Preservation Department – Item 1, LPC-23-08657

**346 Broadway (aka 108 Leonard Street, 46 Lafayette Street) – Former  
New York Life Insurance Building – Individual and Interior Landmark  
Borough of Manhattan**

# DESIGN REVISIONS

## IN RESPONSE TO COMMISSIONER COMMENTS

## VIEWING ROOM ENCLOSURE

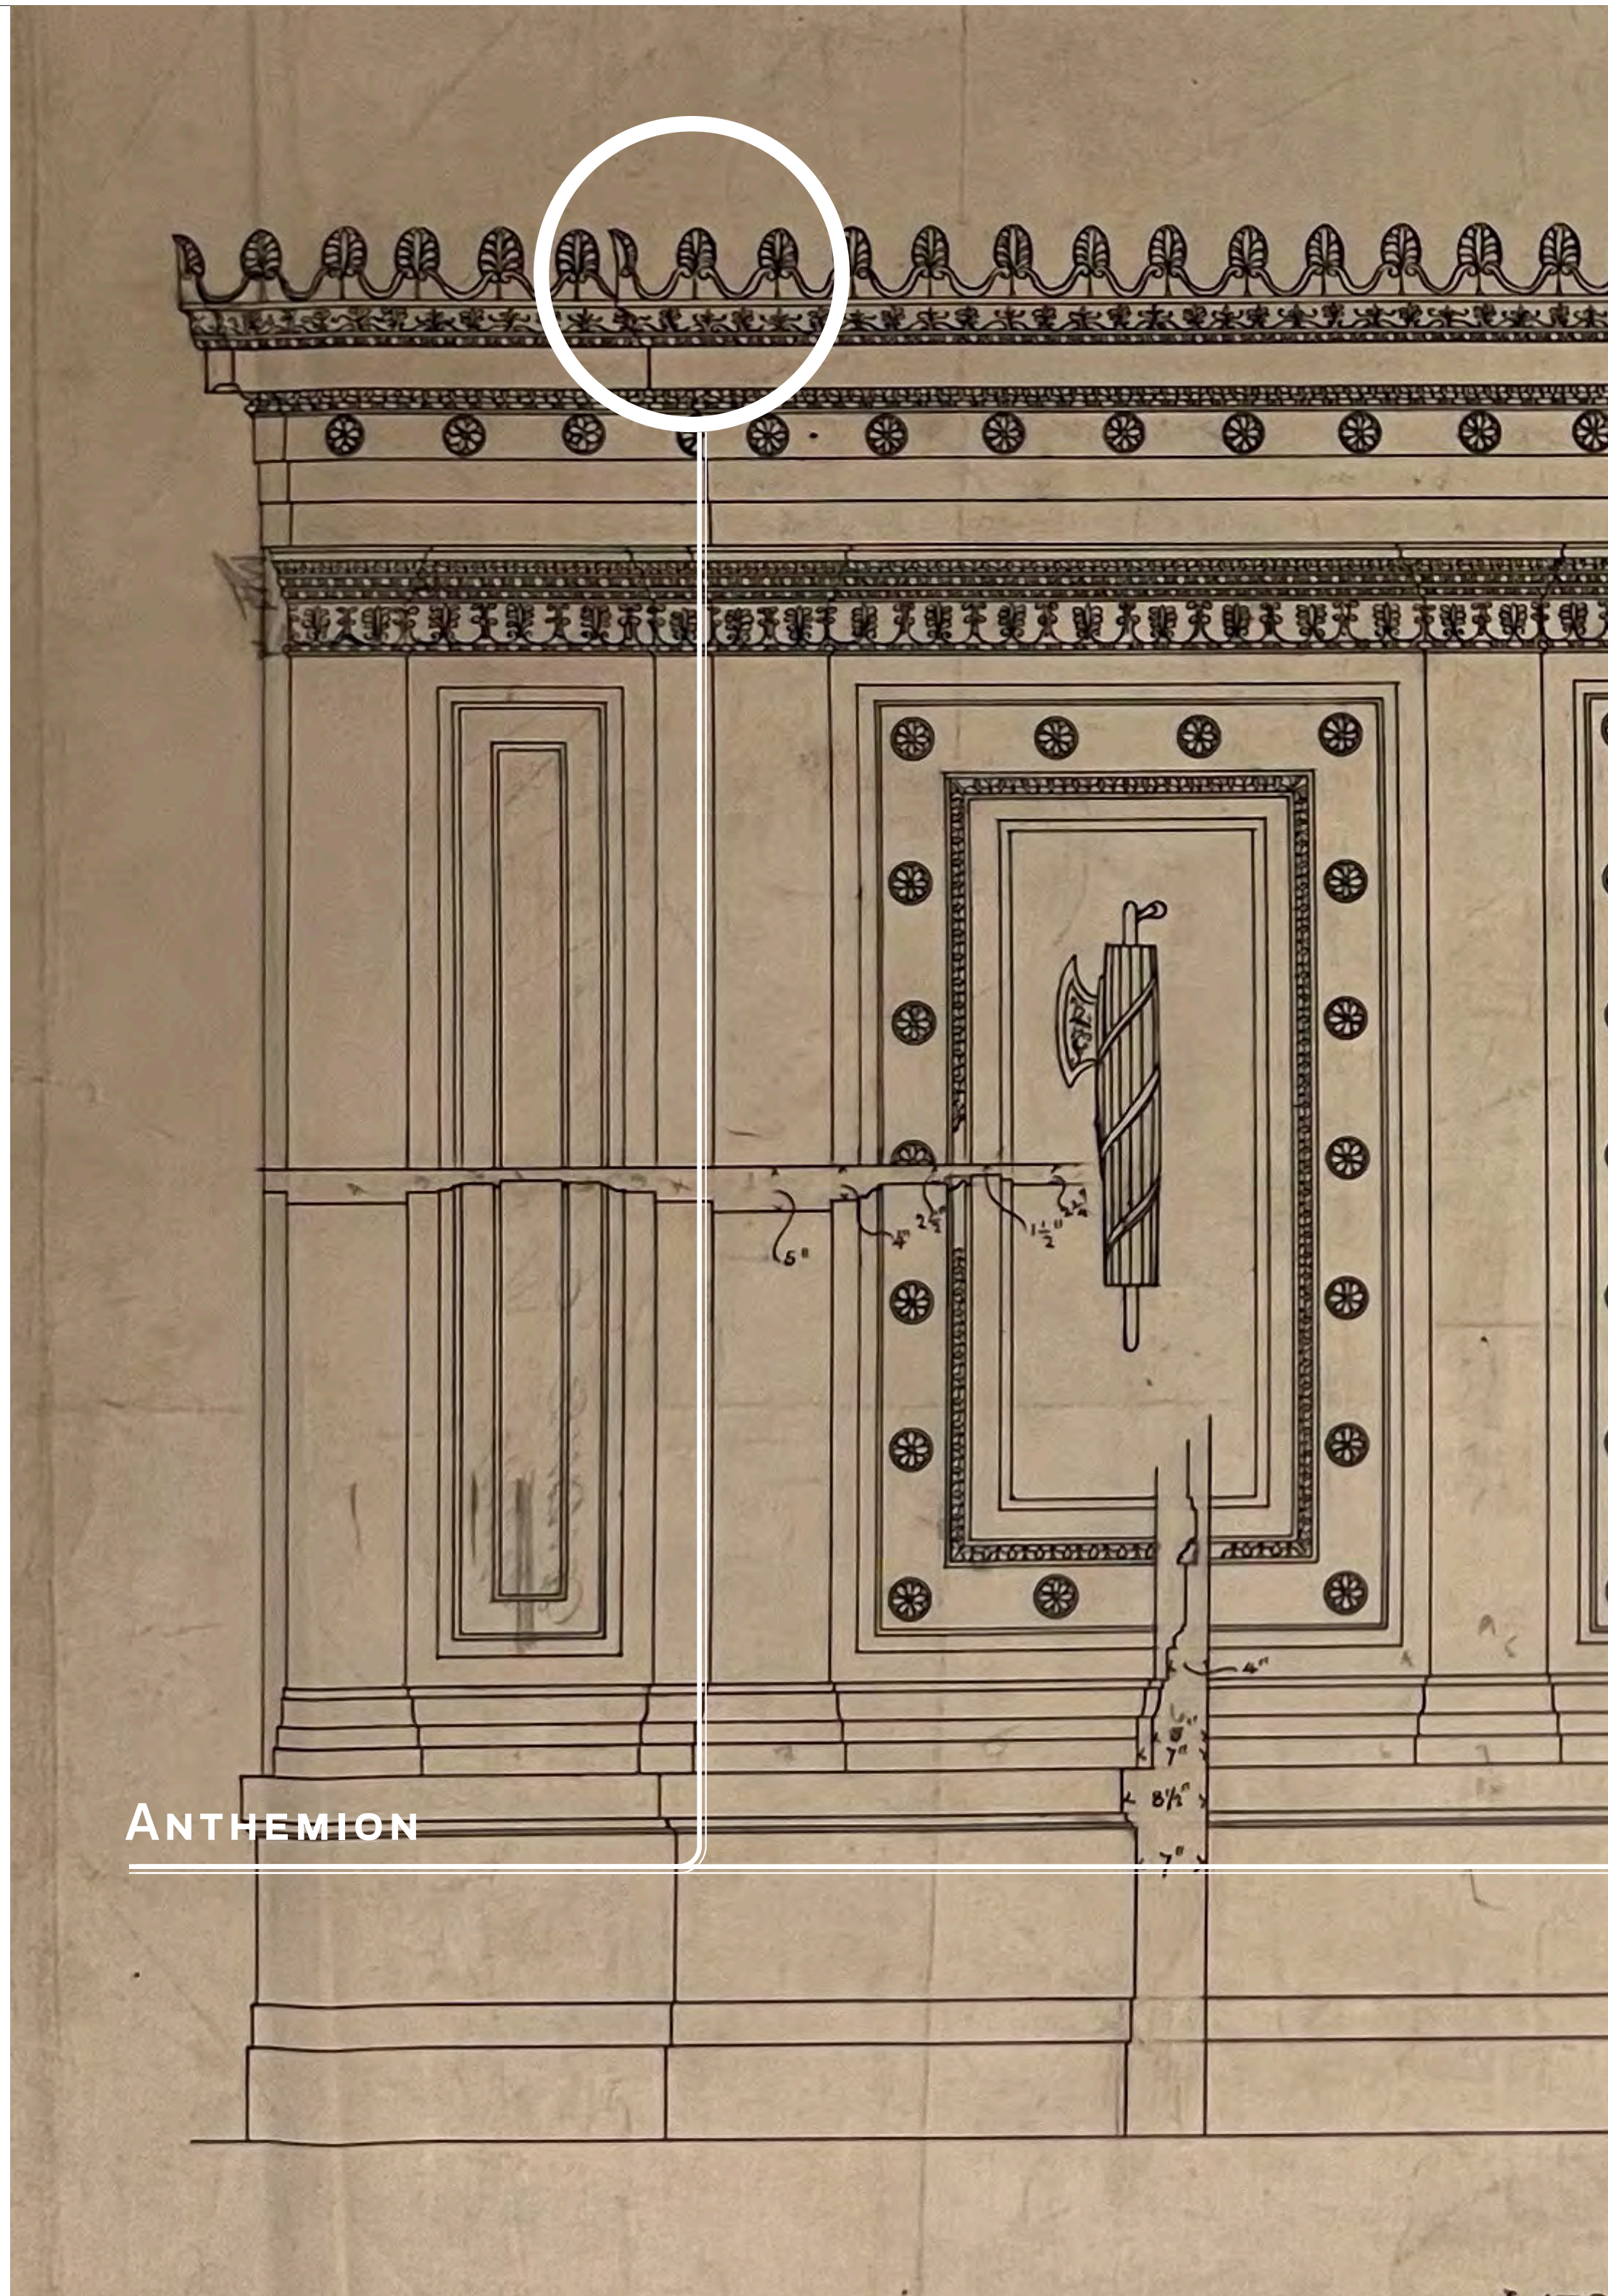
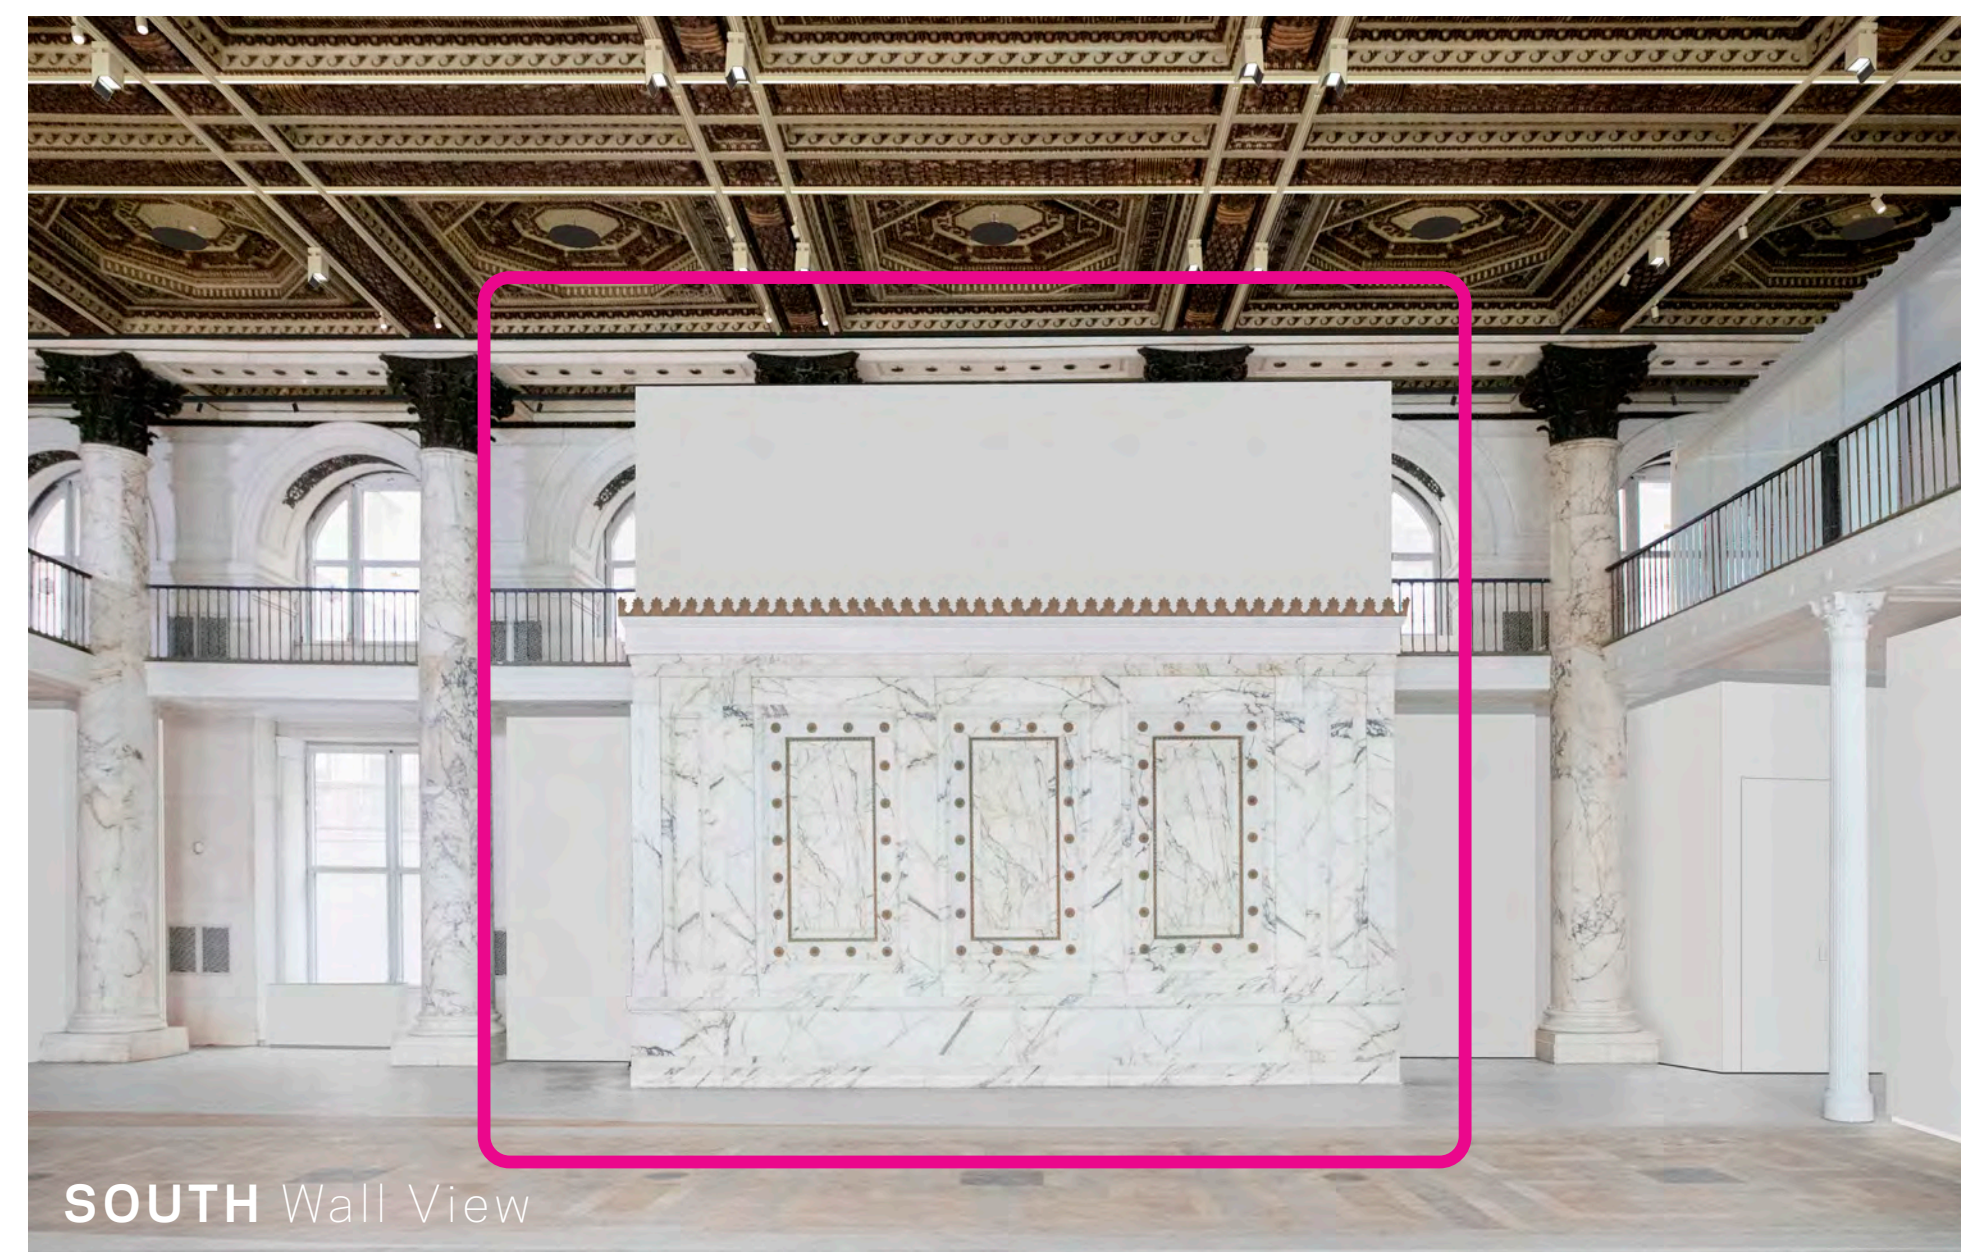
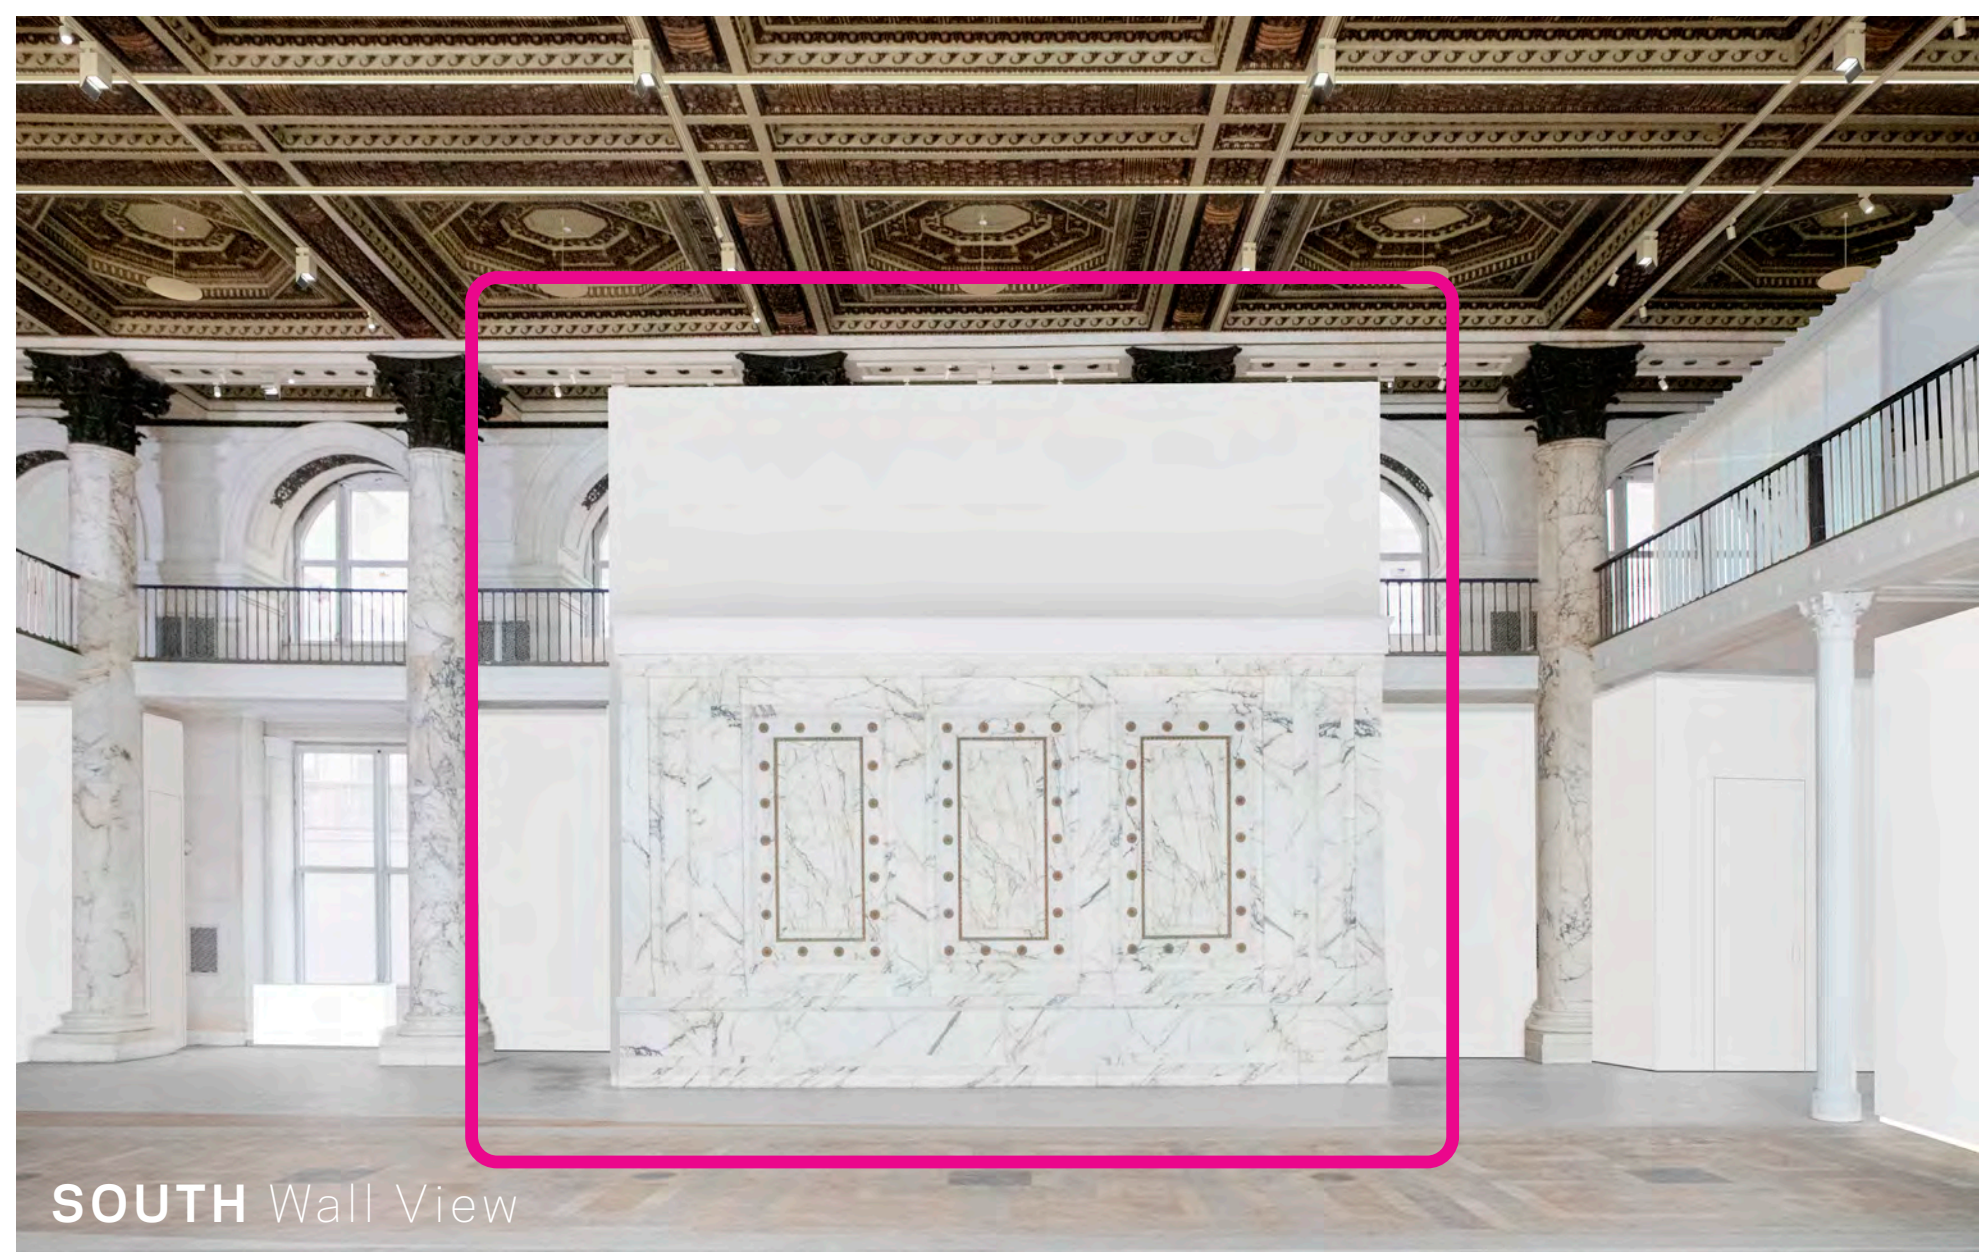
To address the commissioners' concerns about the design, detail and impact on the vault and its relationship to the overall space, the feature wall has been eliminated and the enclosure reconfigured in a symmetrical composition, an interpretation of the solidity and regularity of the vault below. The partitions are set back to the recessed plane of the marble, allowing the cornice to project from the facades. Recreated cresting, which originally existed at the vault's top, provides a stronger termination to the vault. A reveal at the base of the enclosure will provide a physical and visual break above the cornice.
